May 8, 2026

**ADDENDUM #3
NWIT-26-02
SA-11, SA-12, and SA-16 Sanitary Lift Station Upgrades
New Westminster, BC**

This addendum modifies the Invitation to Tender only as noted:

TITLE:		DESIGN: MDJ	CHECK: JAH
SA-11 PUMP STATION SECTION VIEWS & BOM		DRAWN: KDD	APPR: JAH
		A & M FILE: 24-5038	
PROJECT NO.	SCALE : AS SHOWN HORZ. N/A VERT. N/A	DRAWING DATE: JUN, 2025	
DRAWING NO.	A & M DRAWING NO. 24-5038- P01	SHEET NO. 02 OF 04	REV. 04

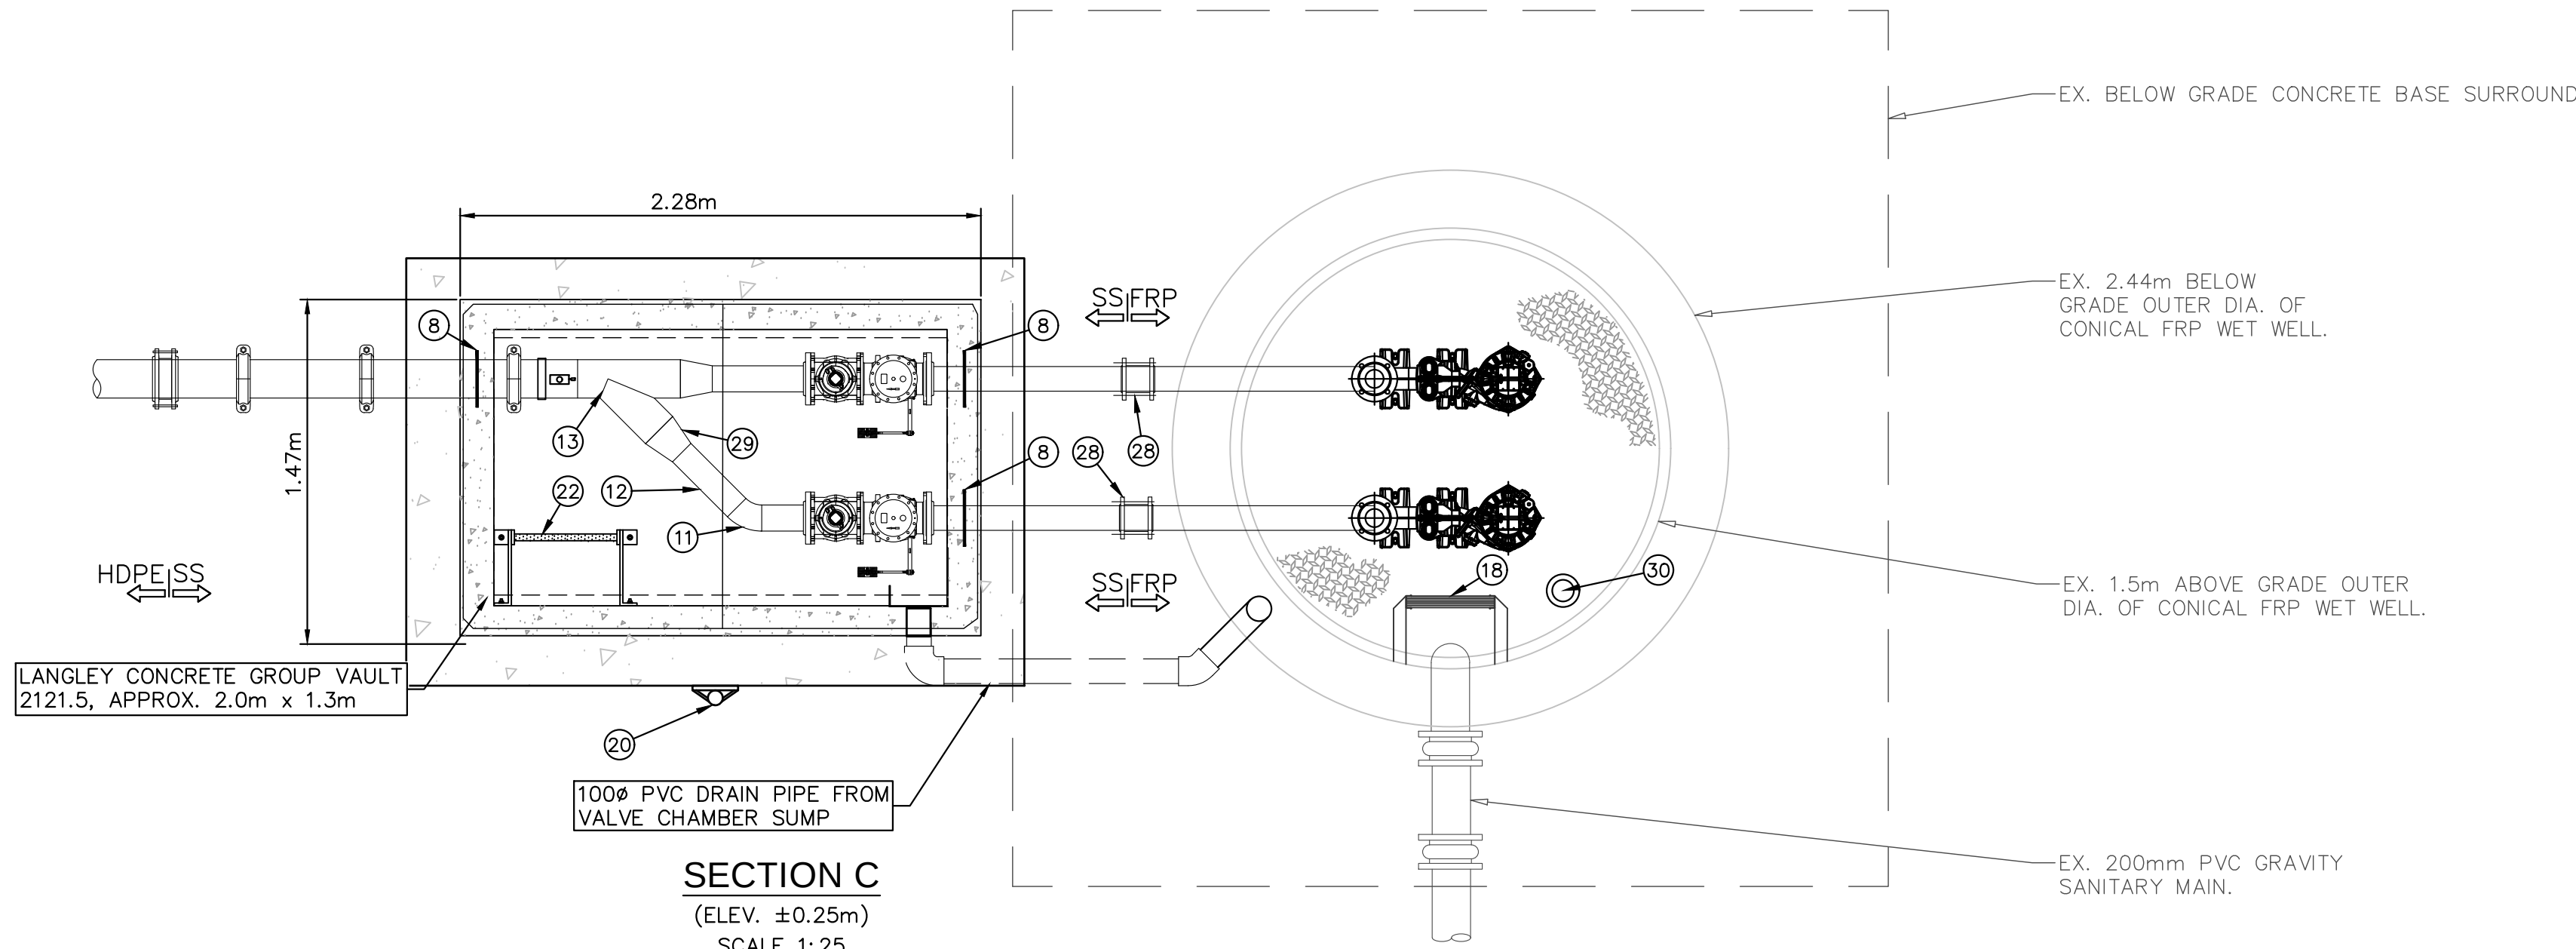
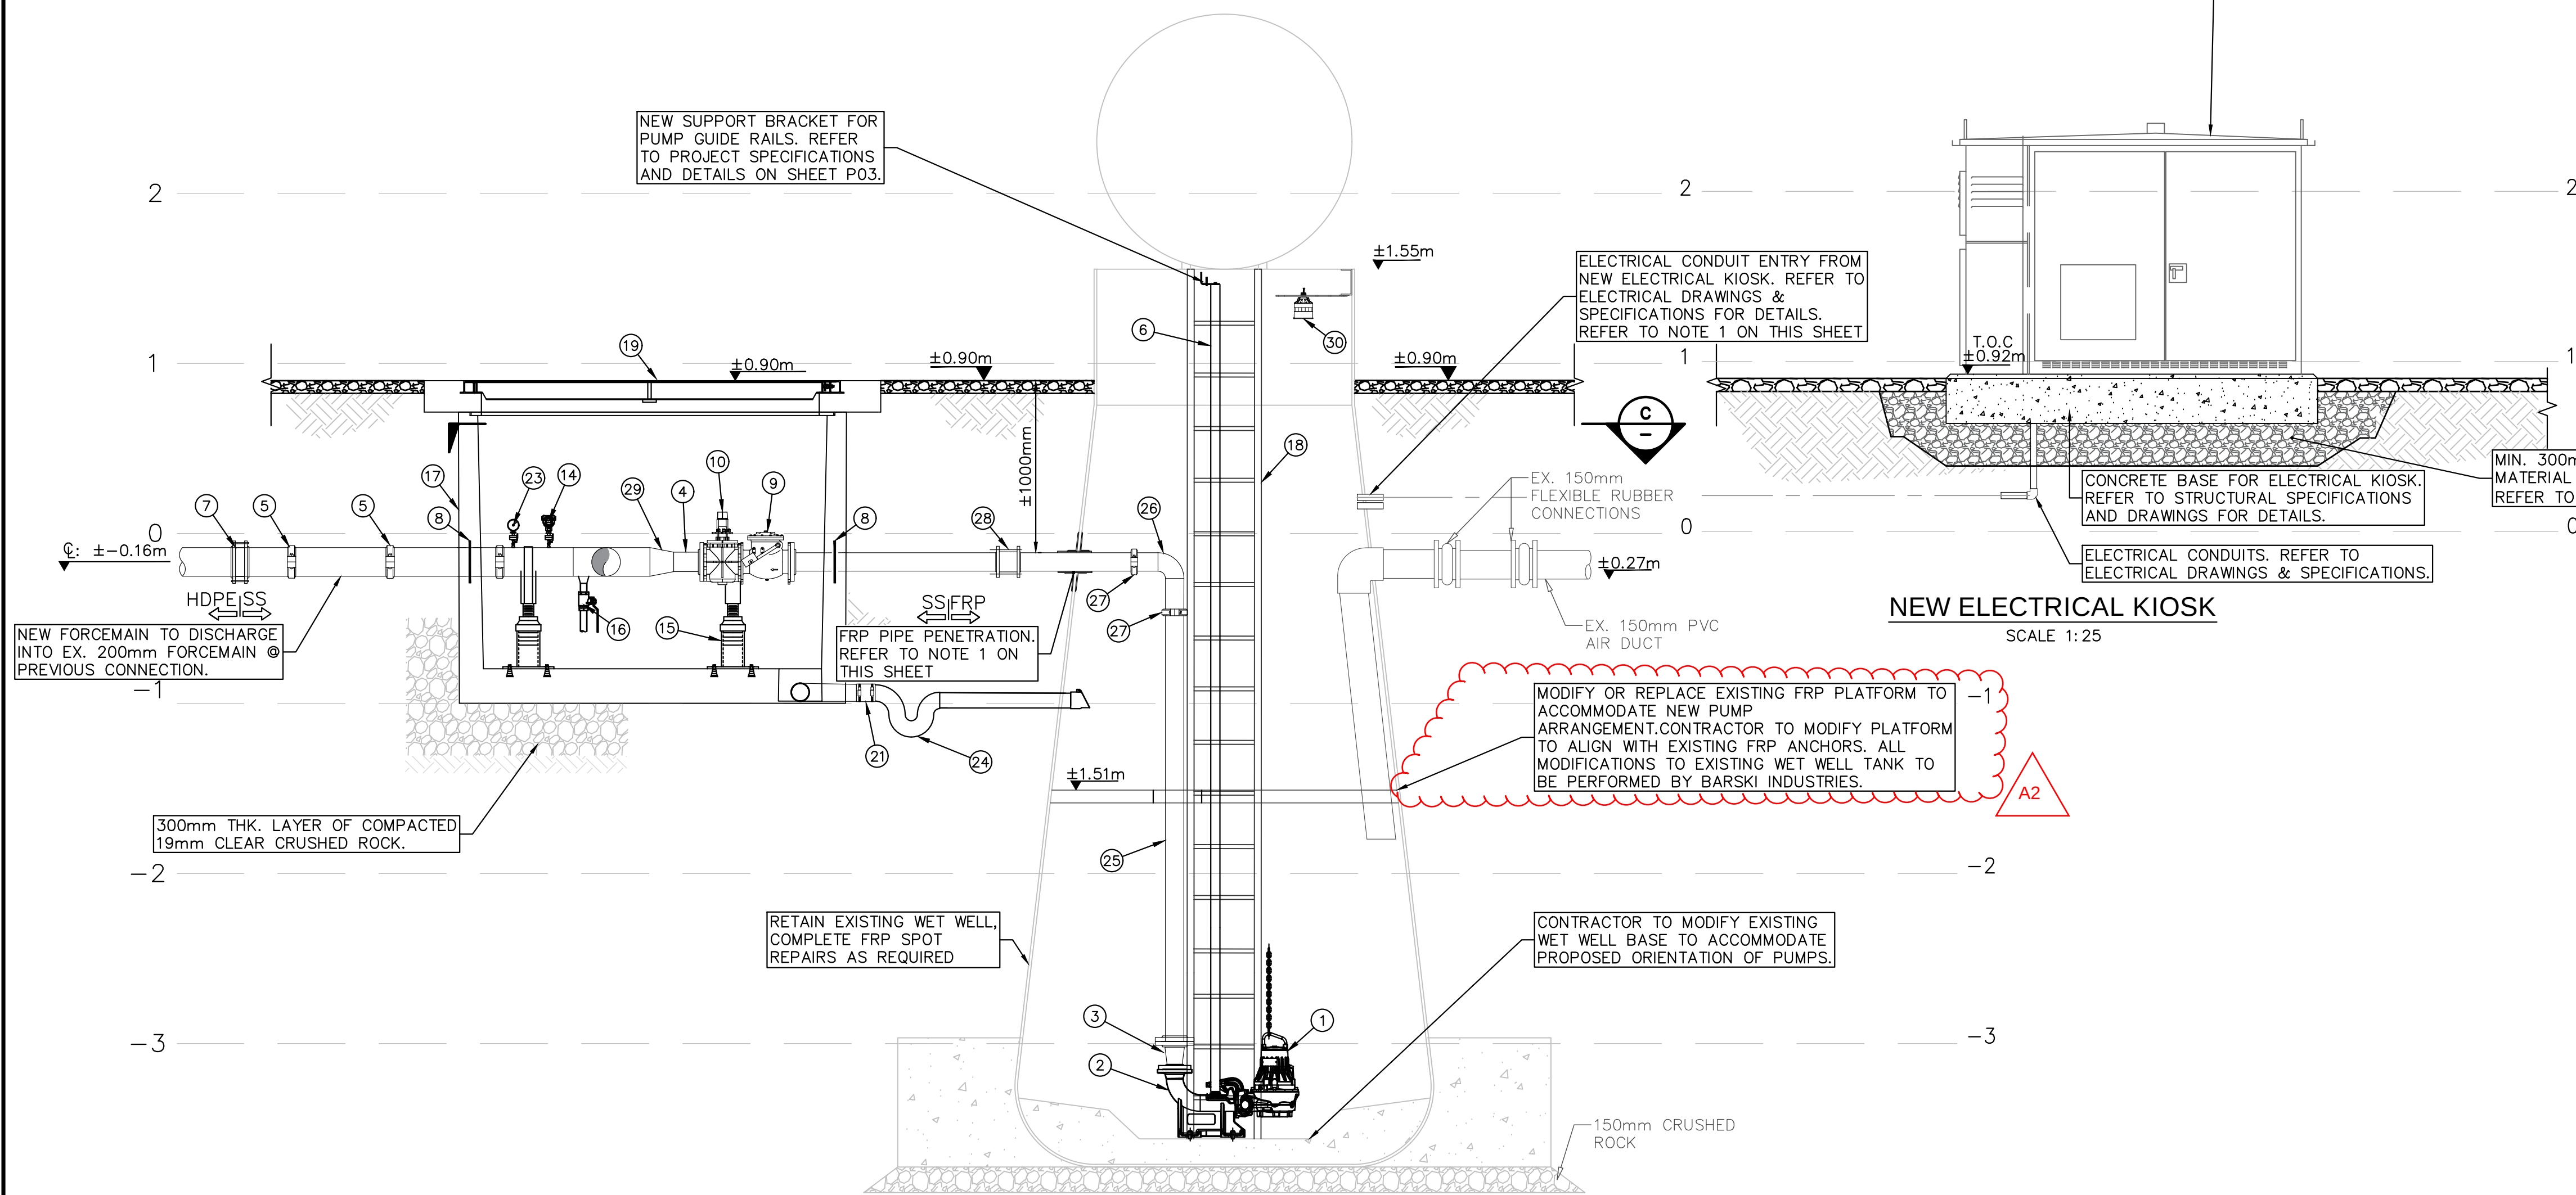
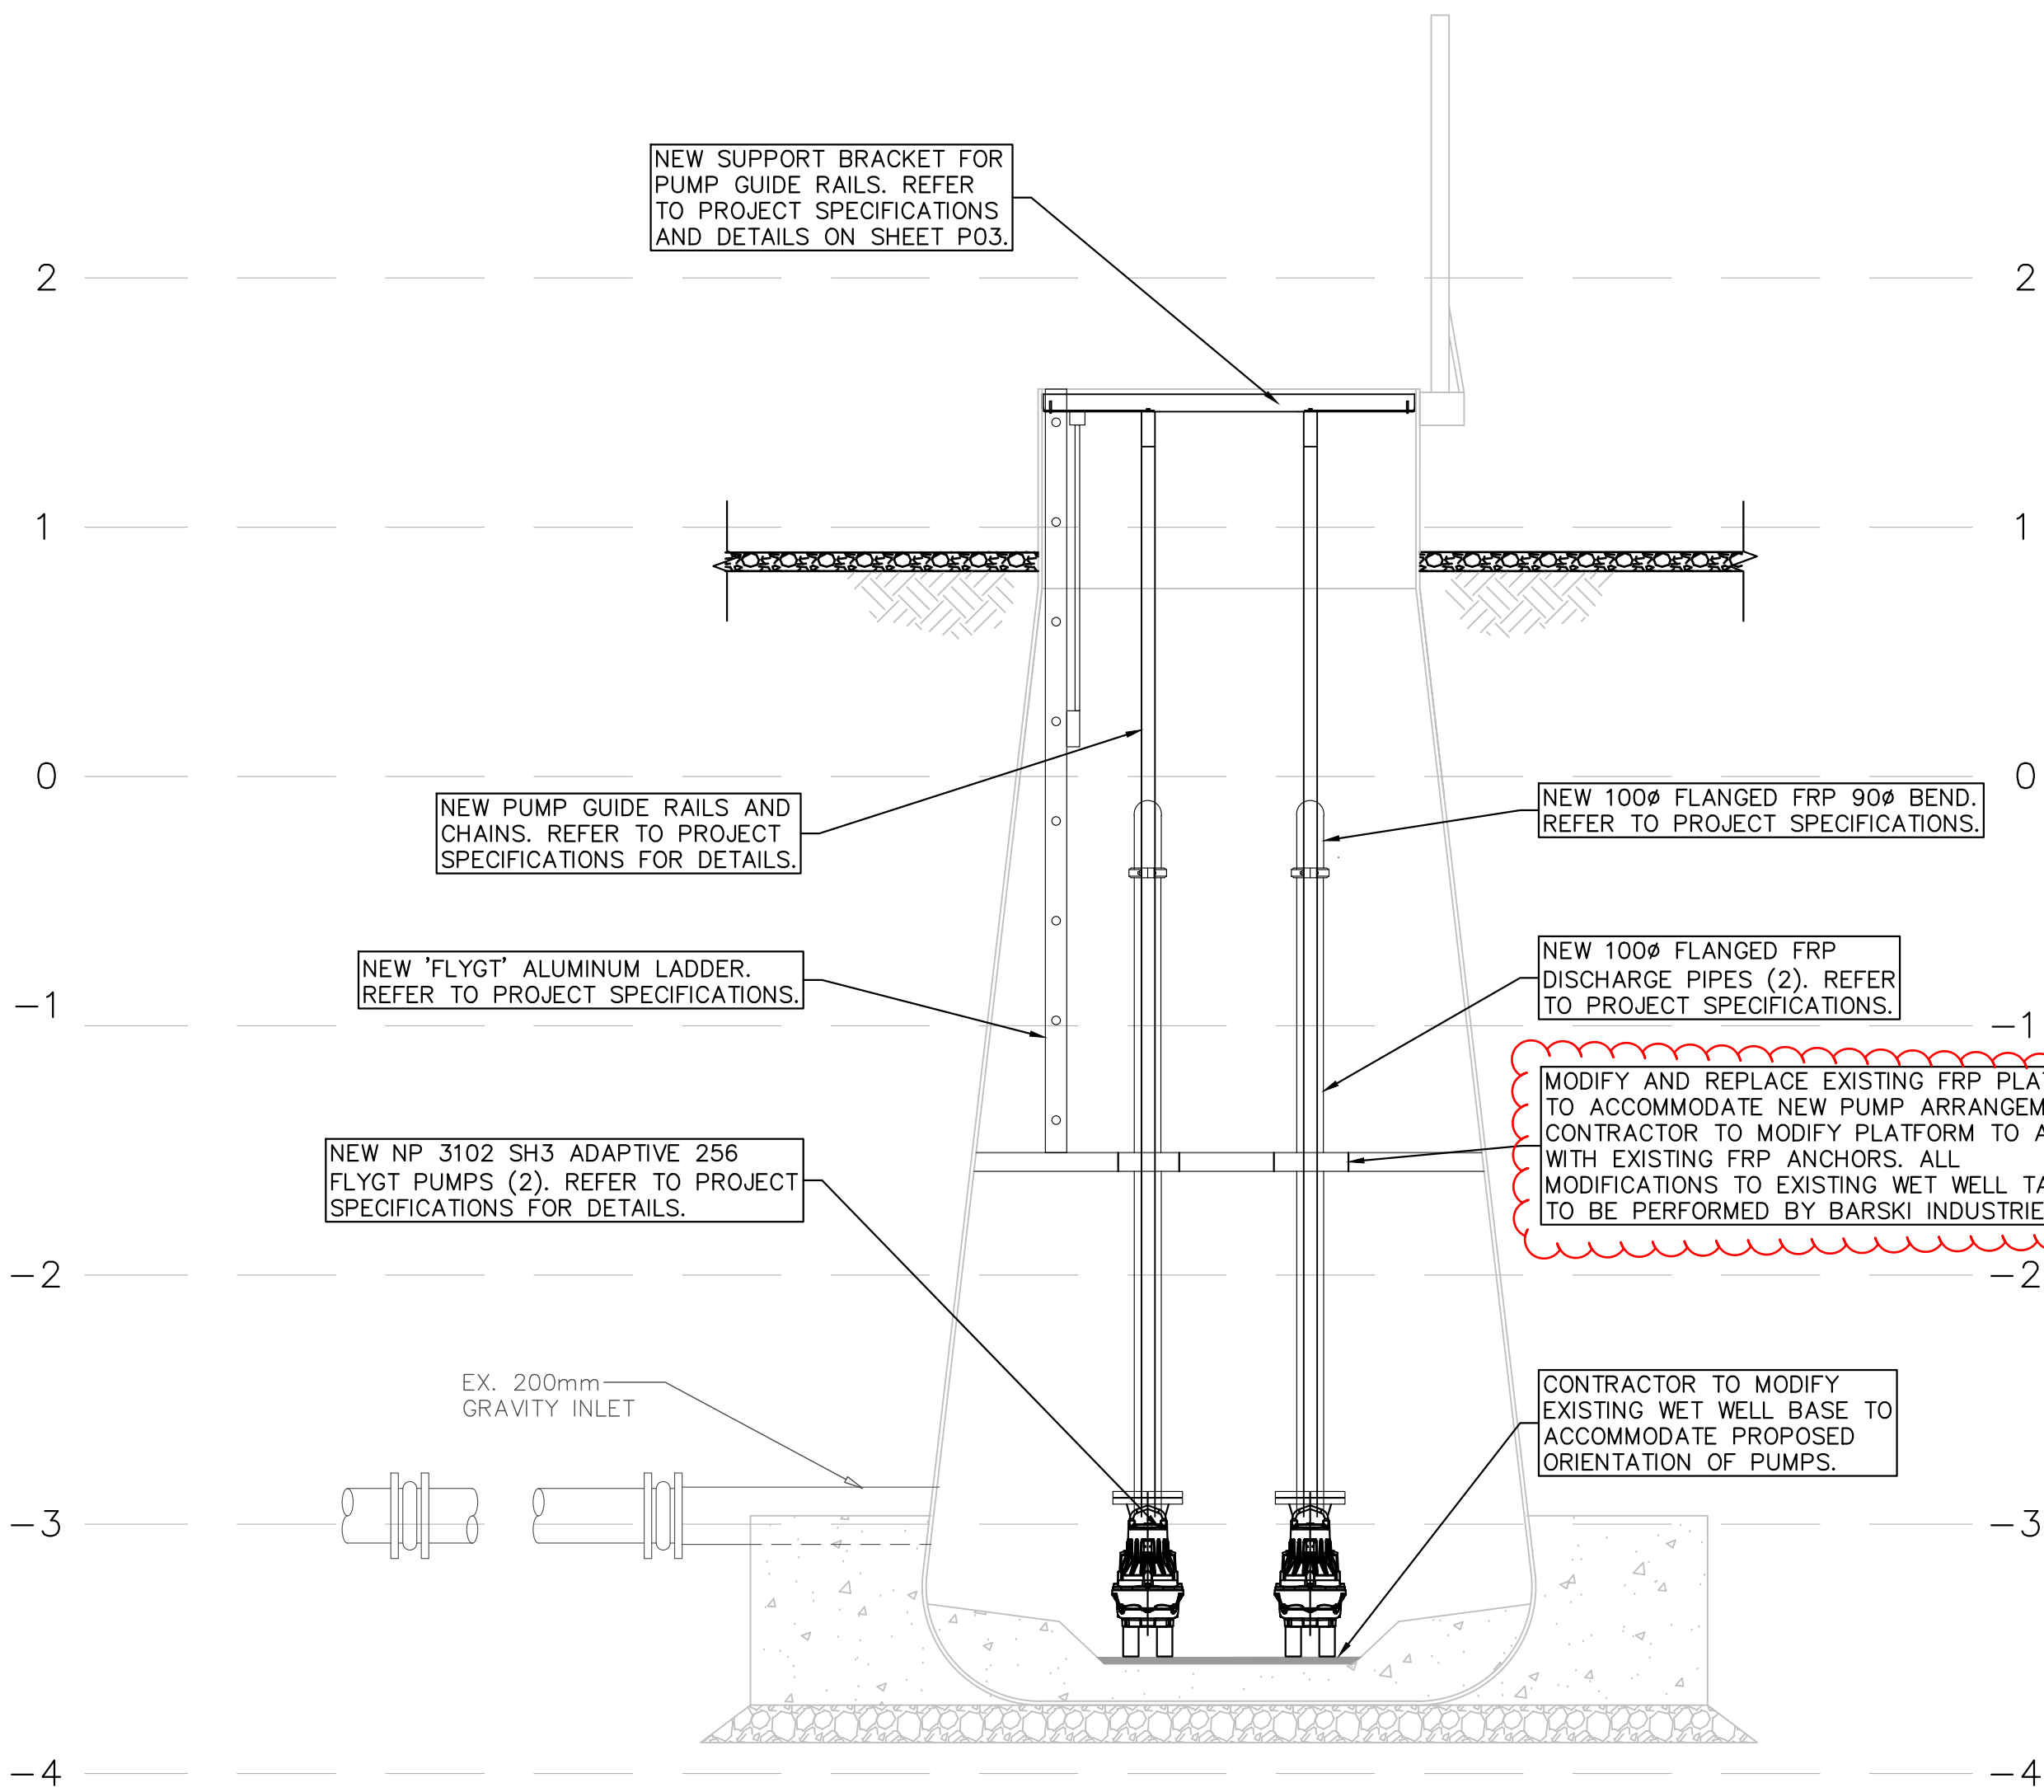
Please find attached the revised SA-11 P01 drawings, including an updated note regarding the intermediate platform.

- Q20 SA-11 Dwg P01 calls for SS316L SCH10 as well as FRP discharge forcemain pipe. Confirm only the piping in the wet well for SA-11 is to be FRP. The other stations do not have FRP pipe.
A20 [FRP piping has been specified for SA-11, assuming potential cost savings with Barski on site. Contractors may propose stainless steel piping as an alternative.](#)
